MIL-H-17902F(SH)  
 AMENDMENT 1  
 12 December 1990

HOSE, END FITTINGS AND HOSE ASSEMBLIES,  
 SYNTHETIC RUBBER, AIRCRAFT FUELS

This amendment forms a part of MIL-H-17902F(SH), dated 23 December 1988, and is approved for use by the Department of the Navy and is available for use by all Departments and Agencies of the Department of Defense.

FIGURE 3. Partial detail of female coupling end.

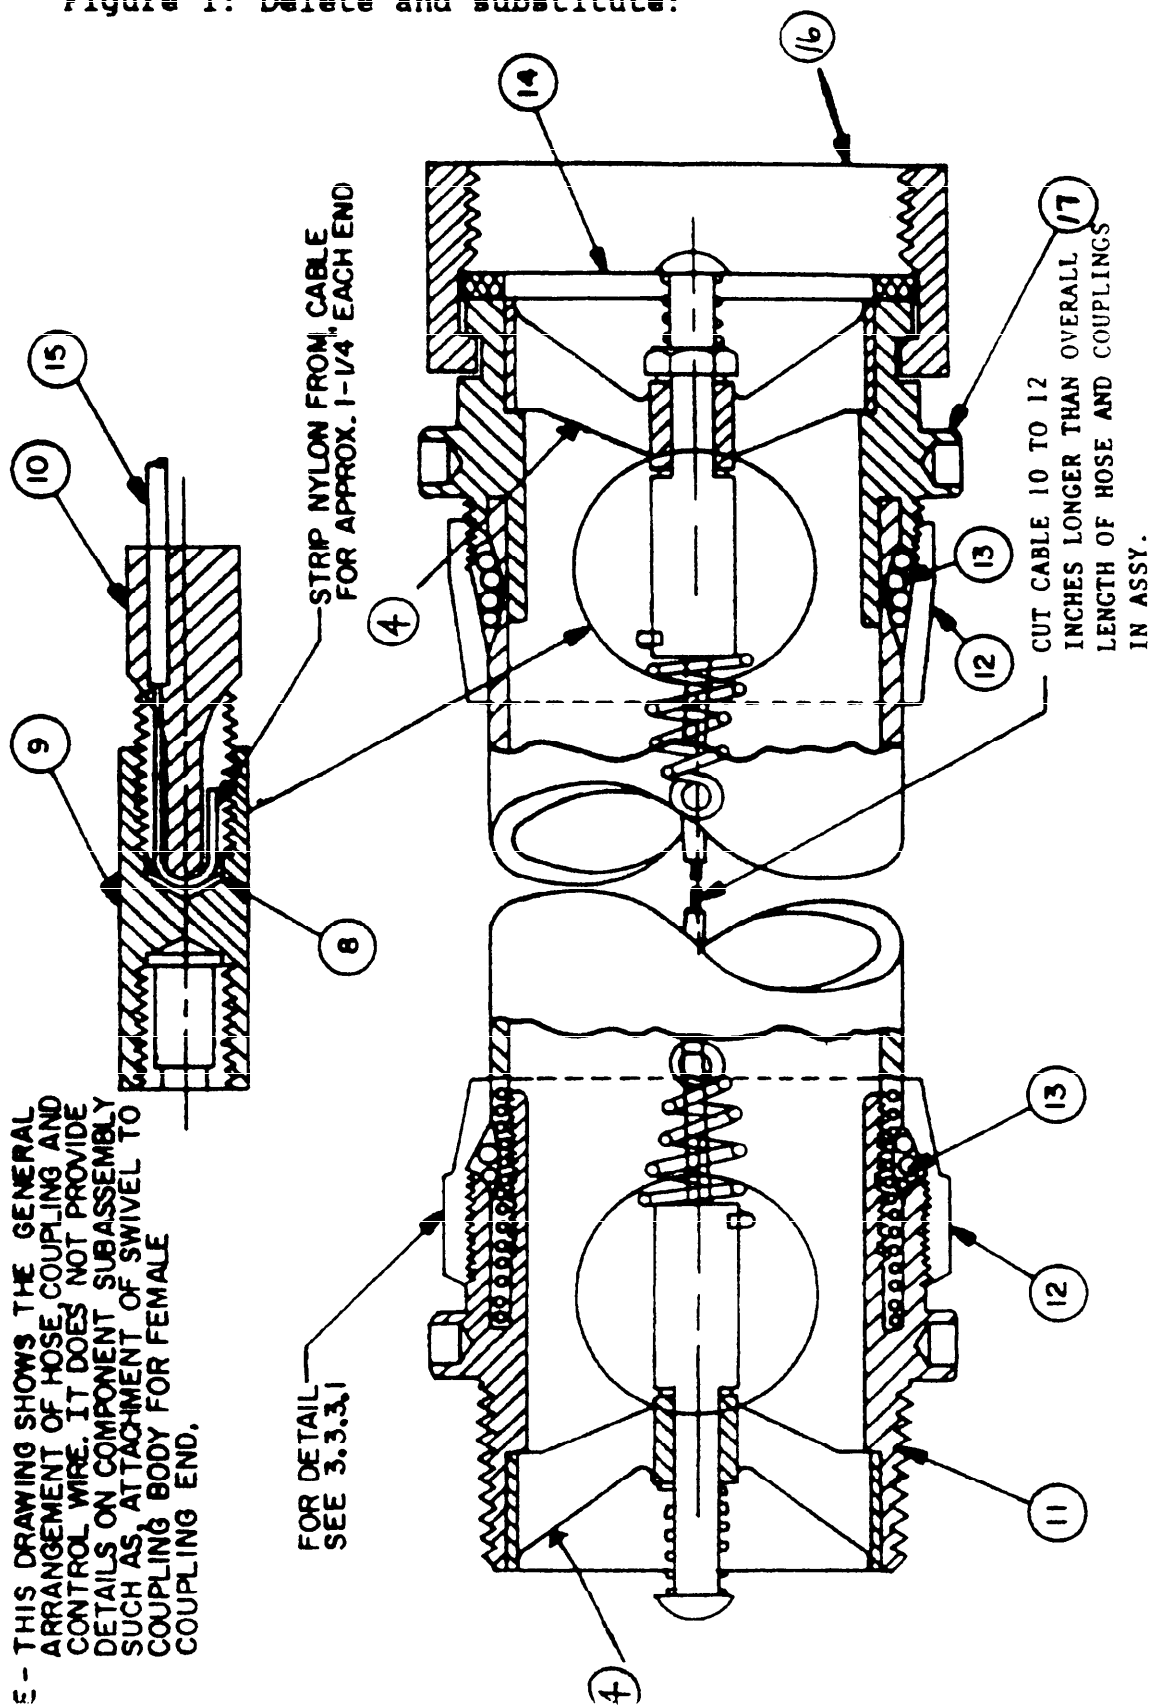
Figure 3: Delete and substitute:

SIZE	F	G	H	I	J	K
1-1/2	0.560	1-1/2 - 11-1/2 NPT	1.52	19/32	15/32	1/8
2-1/2	.781	2-1/2 - 8 NPT	2.52	15/16	11/16	3/16

FIGURE 1. Hose and control wire assembly.

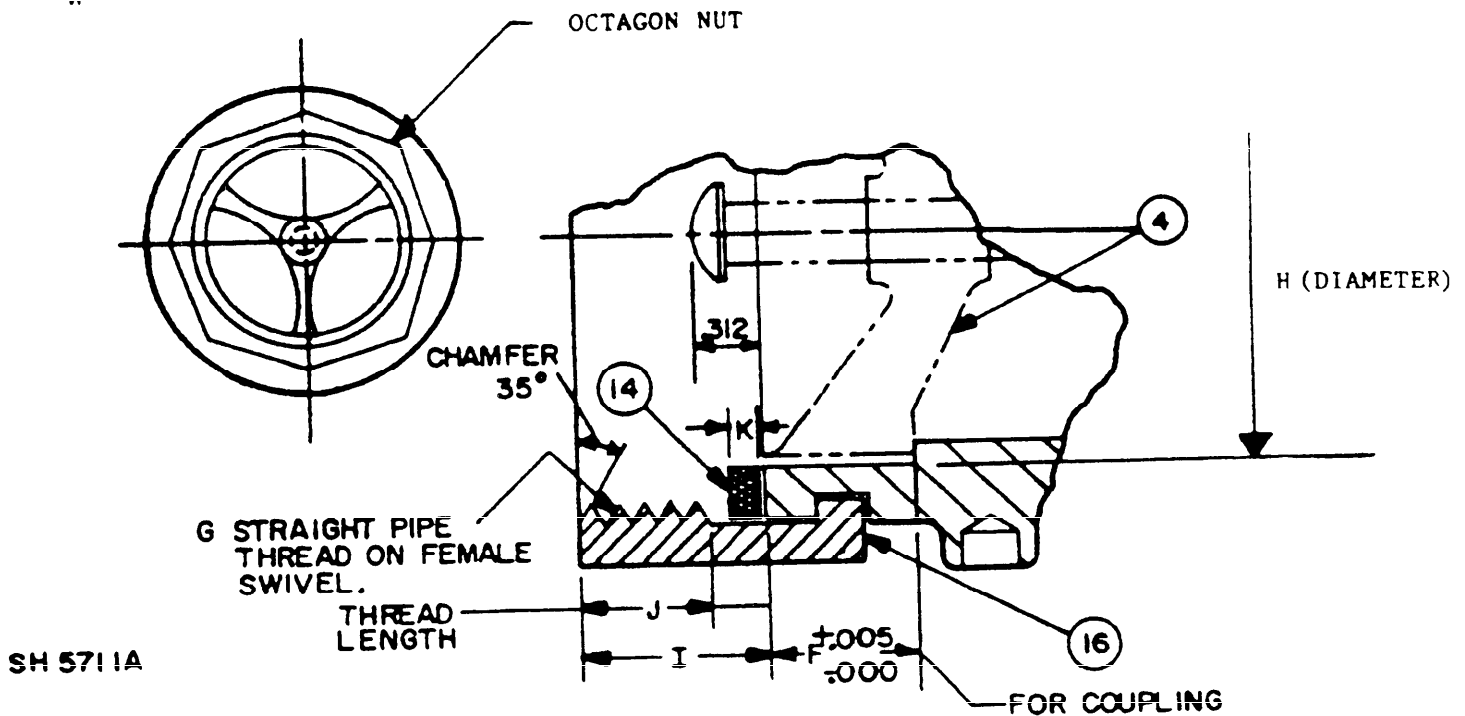
Figure 1: Delete and substitute:
